Site Accessibility Evaluation

Black Forest Park & Ride PU18-0082

SUBJECT: Black Forest Park & Ride Self-Evaluation

Image of obstructed curb ramp landing

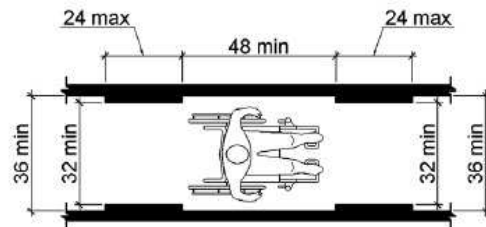
Finding: 3

The walking surface is obstructed. A 36" minimum clear walking surface is required. Many of these bollards have now fallen down into the ramp area which blocks more of the accessible route on the ramp face.

The level landing is not clear for at least 36".

Move the bollard to provide at least 36" width.

Image of fractured sidewalk

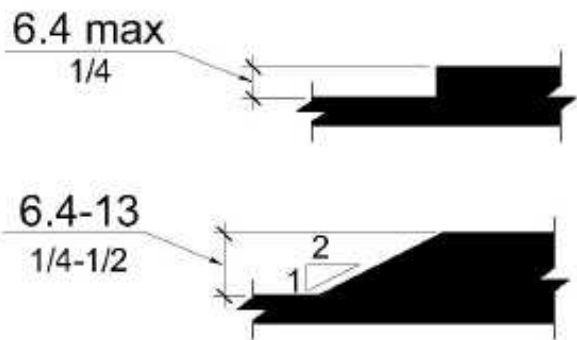
Finding: 5

The sidewalk damaged by vehicle.

The new sidewalk is fractured.

Replace the two panels.
